SS 1034783 20K Detroit Axle King Pin Lube Access

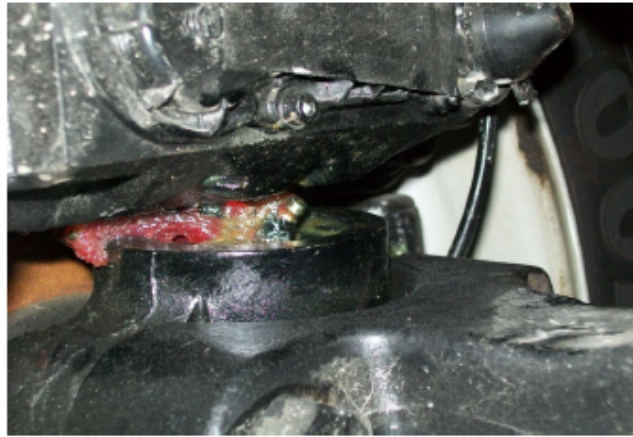
WST trucks equipped with 20k Detroit front axles and disc brakes built up to 8/17/2020 do not have sufficient room to access the king pin grease zerk.(see below)

Retro fit axle for remote grease zerk. See pictures below.
